January 31, 2014  
L-2014- 023

Re: Turkey Point Units 3 and 4  
Docket Nos. 50-250 and 50-251  
Response to NRC Request for Information Pursuant to 10 CFR 50.54(f) Regarding the Flood Hazard Reevaluation Report (FHRR), Recommendation 2.1 –Flooding

**Response to NRC Request for Information Pursuant to 10 CFR 50.54(f)**

**Regarding the Flood Hazard Reevaluation Report (FHRR)**

Figure 2-1: Front-Loaded Temporal Distribution for 60-Minute LIP

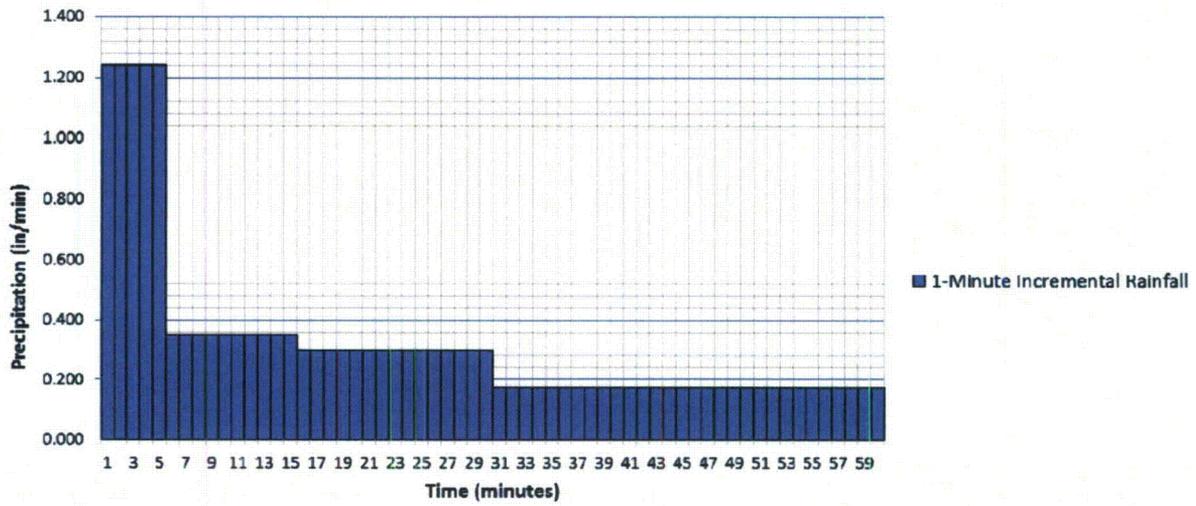
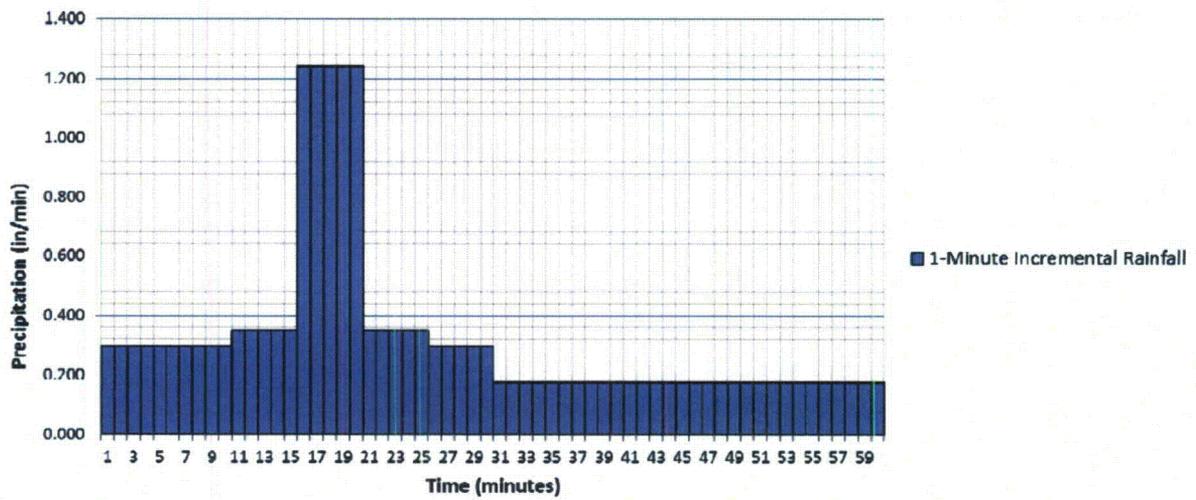
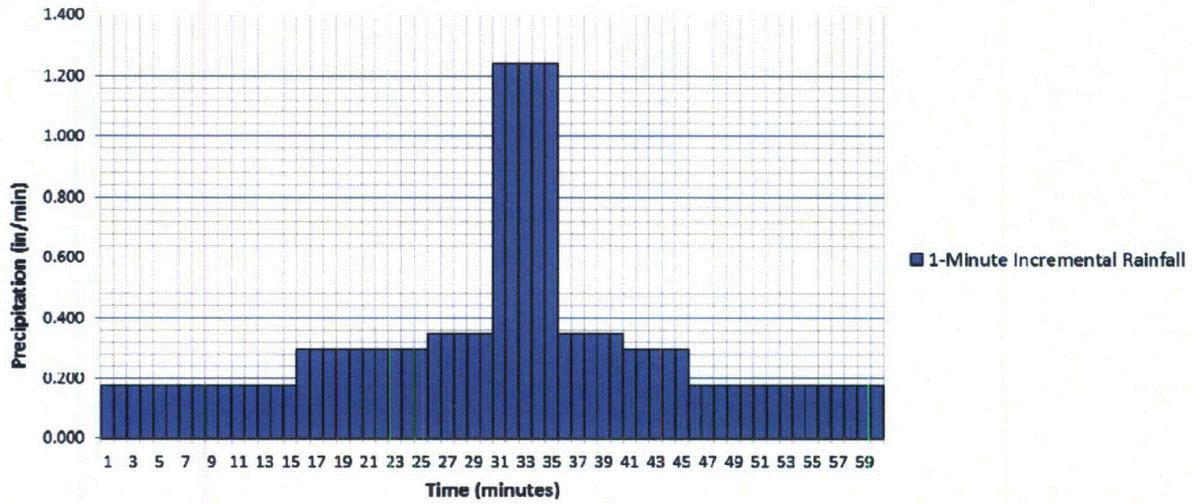
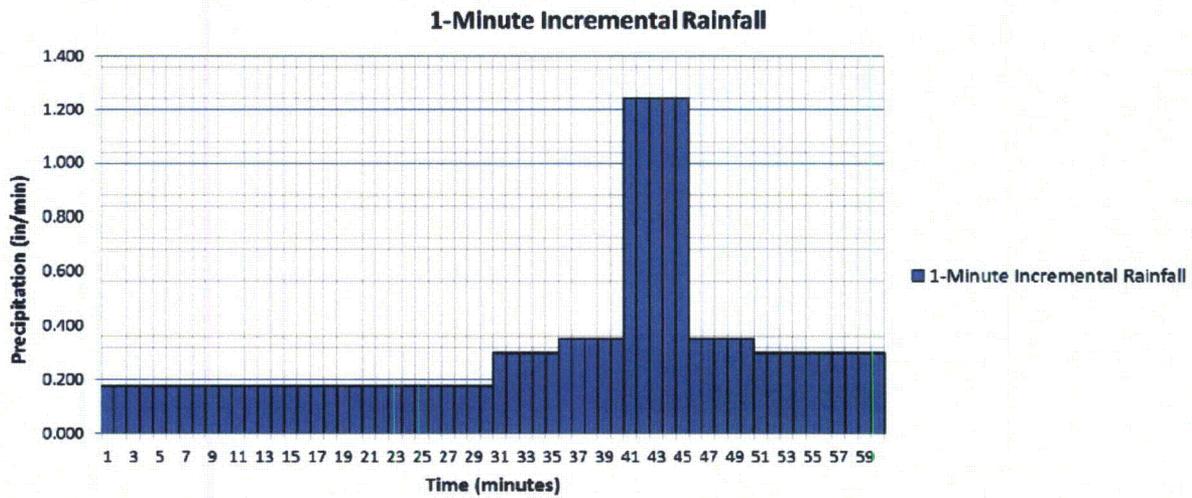
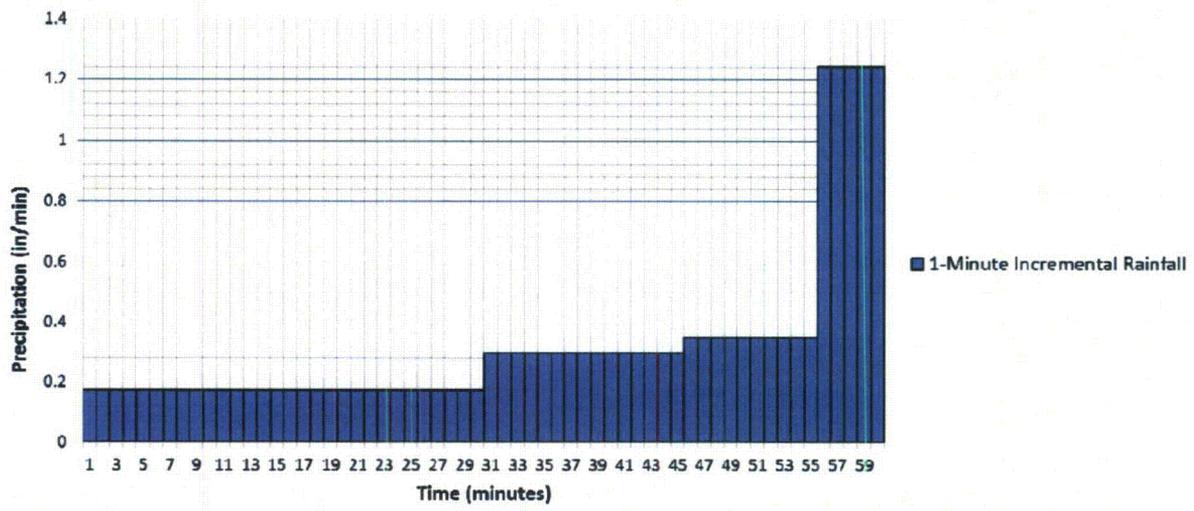
The licensee's analysis of local intense precipitation (LIP) from the 1-hour probable maximum precipitation (PMP) event uses a center-loaded distribution for this event. In order to demonstrate the suitability of the method and level of conservatism, the NRC staff requests the licensee to provide a description of the basis for selecting a center-loaded temporal rainfall distribution for analysis of the one-hour probable maximum precipitation (PMP) event. The NRC staff also requests the licensee to describe whether the analysis of this rainfall distribution is bounding for the effects of PMP-induced flooding at the site.

To determine if the center loaded LIP distribution produces bounding results, a sensitivity study was performed using front-, front-third-, end-third- and end-loaded LIP distributions. Using FLO-2D Pro software the resulting flood levels for each distribution were compared to the center-loaded LIP distribution. The results of each distribution are provided in Table 2-1.

The 5-, 15-, 30-, and 60-minute intensities prescribed by HMR-52 were used to construct the distributions (NOAA, 1982). A one-minute time step was used. A front-loaded temporal distribution has the most intense 5-minute precipitation at the beginning of the total rainfall event, with successively diminishing depth intervals occurring thereafter as shown in the precipitation distribution in Figure 2-1. A front-third-loaded temporal distribution has the most intense 5-minute intensity during the first-third of the total rainfall duration (Figure 2-2), with successively diminishing depth intervals placed on either side of the center of the distribution. A

center-loaded temporal distribution has the most intense 5-minute intensity during the middle of the total rainfall duration (Figure 2-3), with successively diminishing depth intervals placed on either side of the center of the distribution. The end-third-loaded temporal distribution will have the most intense 5-minute precipitation at the end-third of the total rainfall event (Figure 2-4). Lastly, the end-loaded temporal distribution will have the most intense 5-minute precipitation at the end of the total rainfall event, with successively increasing depth intervals occurring beforehand as shown in Figure 2-5. In all cases, the cumulative precipitation is identical: 19.4 inches.

Each distribution was used as precipitation input to the original FLO-2D Pro model prepared for the flood hazard re-evaluation report (FHRR) for LIP effects. The results of the five runs demonstrate that the front and front-third-loaded LIPs produced somewhat lower depths. The center, end-third and end-loaded distributions produced similar results with some depths higher. Only two points (13 and 15) of interest experienced an increase larger than 0.05 feet (0.09 and 0.06 feet respectively) in maximum flow depth as compared to the center-loaded case. Location 13 is on the outside of the Unit 3 emergency diesel generator flood berm which has a maximum height of 21.9 feet NAVD88 well above the new flood level of 18.98 feet NAVD88. Location 15 is outside the Unit 3 Spent Fuel Pool heat exchanger (SFP HX) room which has a critical elevation of 17.36 feet NAVD88. The new flood height of 17.11 feet NAVD88 remains below the critical elevation for the SFP HX room. The impact of the revised maximum flood heights due to the sensitivity study has been incorporated into the results reported in the response to RAI 7.

The sensitivity study has shown that additional precipitation distribution profiles produce slightly greater maximum flood height at two locations and thus the center loaded distribution is not bounding at those locations. Other locations also showed greater flood elevations but not of any significance (less than 0.05 feet). The bounding flood elevation calculation is now based on the maximum flood depth from the combination of the profiles listed in Table 2-1 and not a single distribution profile. Affected documents have been revised to reflect this new approach.

**Figure 3.1 – FLO-2D Computational Schematic. A) Example Configuration of Computational Elements with Corresponding Elevations. B) Example of Inflow and Outflow Experienced in Computational Element 5. Figure modified from FLO-2D (2009).**

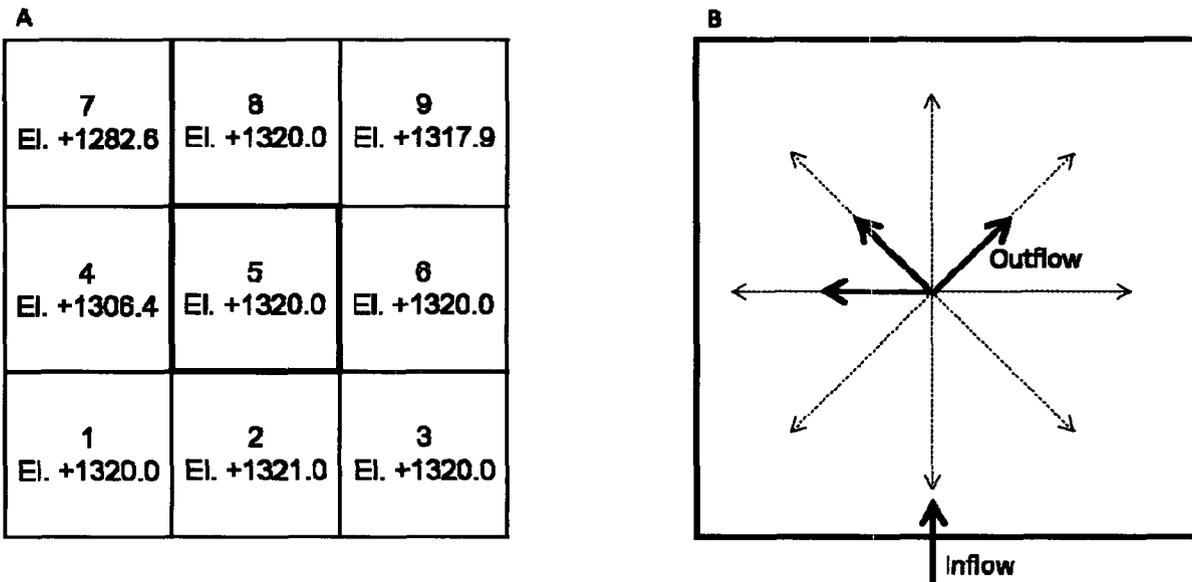
The NRC staff's review of the local intense precipitation (LIP) flooding hazard analysis around the powerblock area indicates a need for additional descriptions in order to demonstrate the appropriateness of the modeling approach used for determining the localized water levels and flow velocities from the PMP event. For LIP Scenario A, the FLO-2D numerical model was

used to simulate the flow of runoff at the powerblock and its surrounding areas. The NRC staff requests the licensee to provide justification to demonstrate the structure and scale of this model application is appropriate for simulating flow within spaces between buildings and structures with sufficient accuracy and spatial resolution in order to predict water levels and velocities at specific doorways and other critical locations within the power block.

Two-dimensional flow in FLO-2D Pro is accomplished through integration of the equations of motion. The following shallow-water assumptions are used to simplify the model, but do limit applicability to the site: no vertical flow acceleration, depth-averaged flow, and no wind nor Coriolis Effect. A schematic example of the computational grid elements is shown in Figures 3-1A and B. Figure 3-1A is a series of 9 connected computational elements (cells), each numbered with their respective elevation, interpolated from a digital elevation model (DEM). Figure 3-1B shows the inflow and outflows for the center cell, element 5. Inflow arrives from element 2. FLO-2D Pro computes outflow in eight directions (dashed arrows), corresponding to each neighboring computational element. In this example, outflow will be directed to elements 4, 7, and 9 (solid arrows). The FLO-2D computations in each element are a composite average of the terrain and flow within it. Thus, it is sufficient to resolve features larger than the element spacing but likely inadequate to include smaller site components.

**Figure 4-1: Runoff over No-Flow Area Schematic**

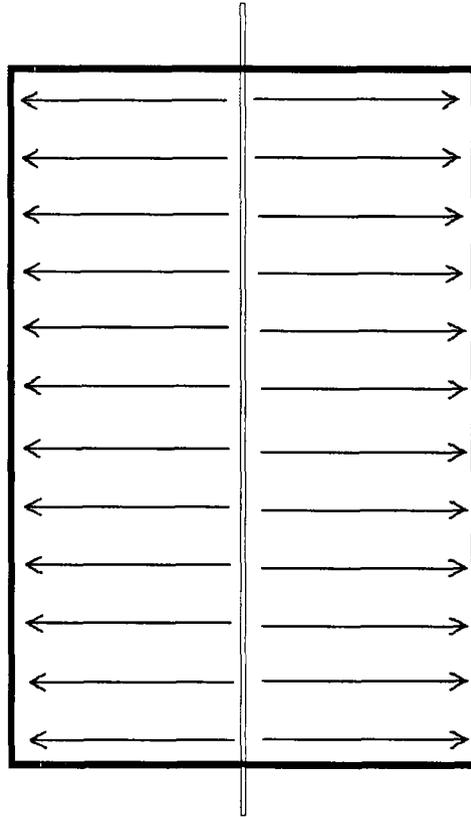
The model documentation for the FLO-2D flood analysis indicates that areas occupied by buildings were treated as no-flow zones in modeling onsite hydraulics, but it does not indicate how the model handled precipitation onto these zones. The NRC staff requests the licensee to describe how precipitation that falls on building roofs would be routed to the ground surface during a flood event, and how the routing of this precipitation is handled in modeling of Scenario A.

Precipitation that falls onto the building roofs was included in the model's mass balance. In the LIP analysis, buildings were modeled as no-flow areas. This option prevents the inflow of water to buildings from computational cells outside the structure, but it does not prevent outflow of water from buildings to computational cells outside (FLO-2D, 2009). Precipitation was introduced to each computational cell within a building/structure (but without inflow). FLO-2D Pro then calculated the runoff from the building area using the topography defined within the footprint of the building. Figure 4-1 shows an example of a no-flow structure with a topographic high running under the center. No precipitation was allowed to accumulate in any no-flow building footprint in FLO-2D Pro; instead inflow was routed to computational cells outside the building (FLO-2D, 2009). For the case presented in Figure 4-1, runoff would be directed to either side of the structure. The precipitation effectively was introduced as inflow to adjacent cells around the building perimeter, as highlighted in the figure below. This approach is akin to assuming complete blockage of roof drainage components while not crediting the roof for any storage capacity.

Figure 5-1: Location of Condenser Pits and CCW with FLO-2D model topography represented.

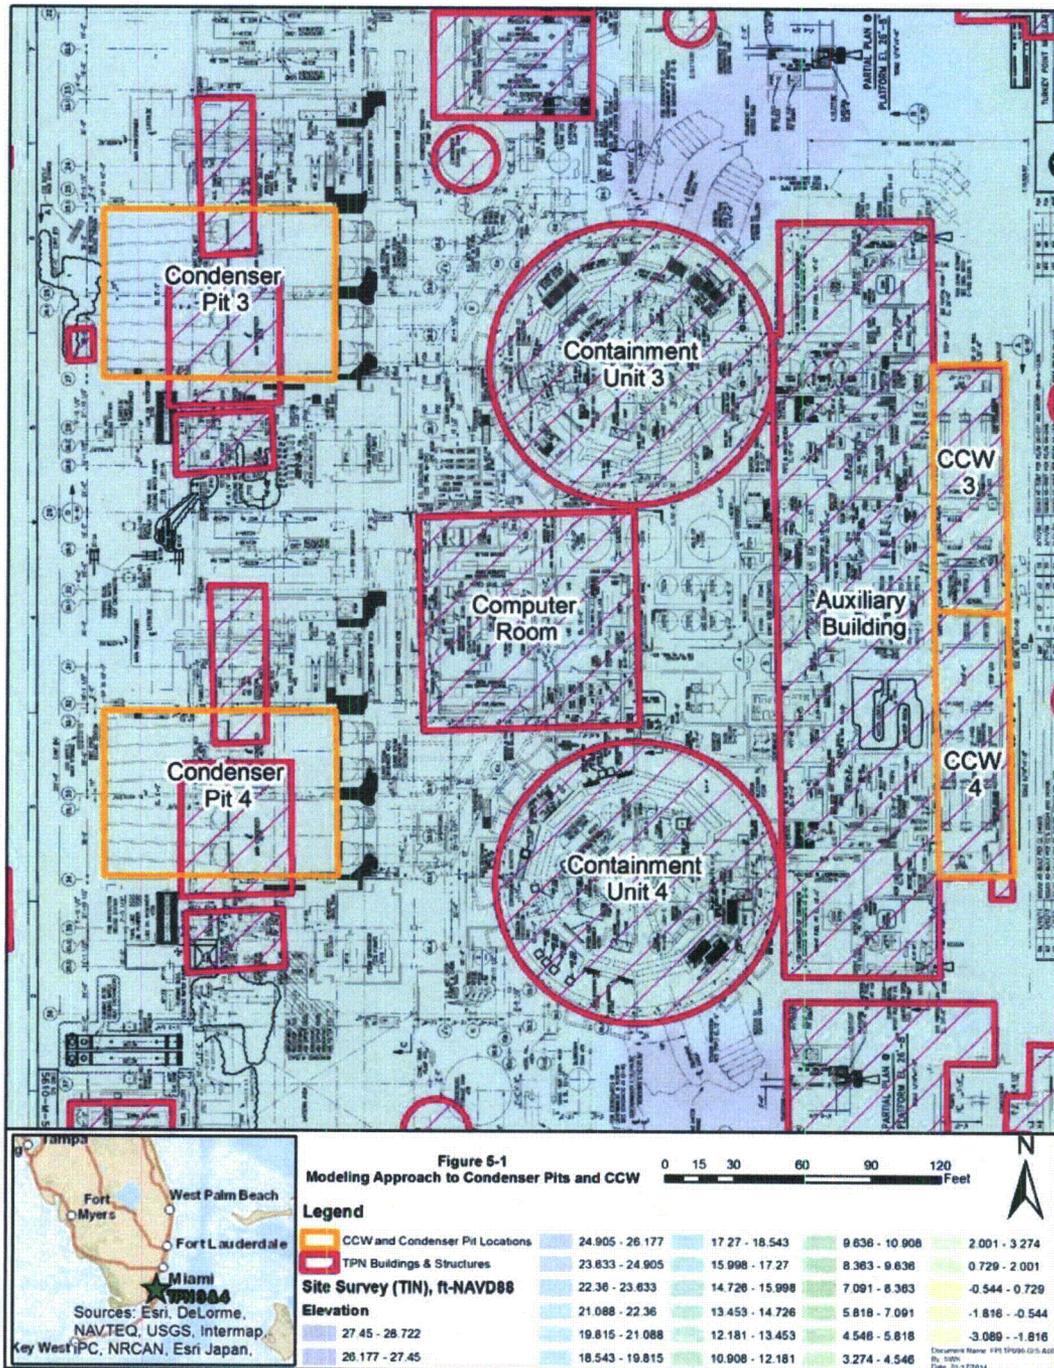
The NRC staff requests additional information to complete its review the modeling of the local intense precipitation Scenario A using FLO-2D. Specifically, the Condenser Pits and Component Cooling Water (CCW) are not discernible as low-elevation areas in the files provided to document model input, nor are they discernible as sites of significant water accumulation in the model output files or on the images (maps) provided to illustrate model results. The NRC staff requests the licensee to provide a description of how the Condenser Pits and CCW Areas for Units 3 and 4 are represented in the FLO-2D model.

The NRC's staff review was correct in noting that the Condenser Pits and Component Cooling Water (CCW) were not modeled as low elevation areas. This approach was selected to increase the level of conservatism by not crediting storage in these areas. The Condenser Pits and Component Cooling Water (CCW) were not represented as low-elevation areas in FLO-2D Pro Scenario A model simulation, as shown in Figure 5-1. Rather, these areas were modeled

conservatively at local grade. This technique did not credit the areas for any storage capacity. Instead, precipitation runoff was directed to computational cells adjacent to the east side of the CCW. Because these low storage volumes are not credited, the model is inherently more conservative.

However, hand calculations were performed to determine the effects of the LIP in the CCW and Condenser Pits with credited outgoing pumping. Those computations found that the maximum accumulated water depth during the LIP scenario B event in CCW3 and CCW4 was 0.88 feet and 0.97 feet, respectively. The maximum depth was greater for Condenser Pits at 7.87 feet for each unit.

Since the FHRR submittal, FPL has revised the Condenser Pit calculation to include additional retention areas previously not accounted for, including additional holdup volume on the east end of the Condenser, and to correct the elevation of the pit. In addition, FPL has reduced the size of the temporary hurricane pumps for the Condenser Pits to enhance deployment prior to a hurricane yet maintain levels well below any critical equipment.

The Condenser Pit is 16 ft deep rather than 22 ft deep as originally reported in the FHRR. The revised results of the maximum Condenser Pit water level for scenario A (non- hurricane) calculation show a new maximum depth in the pit will be 14.8 ft from the bottom of the pit versus the 13 ft reported in the FHRR. The surface elevation of the water would be at elv 14.5 ft NAV88 and the top of the pit is at 15.7 ft NAV88.

The temporary hurricane pumps are deployed prior to onset of a major hurricane. The original basis for sizing the temporary pumps did not take credit for the Condenser Pit holdup volume and consequently sized very large pumps greater than 1,800 gpm for each pit. Reducing the capacity of the pumps will allow a much faster deployment during the 48 hour storm preparation activities and free up resources for other critical activities. Given the available margin in the Condenser Pit for scenario B, a reduction in pump capacity to 600 gpm is warranted to improve storm preparation activities. With smaller pumps the maximum Condenser Pit depth will be 11.8 ft (Elv 12.1 NAV88) versus the 8 ft reported in the FHRR again below the level of any critical equipment. Scenario A still remains the bounding maximum Condenser Pit flood level.
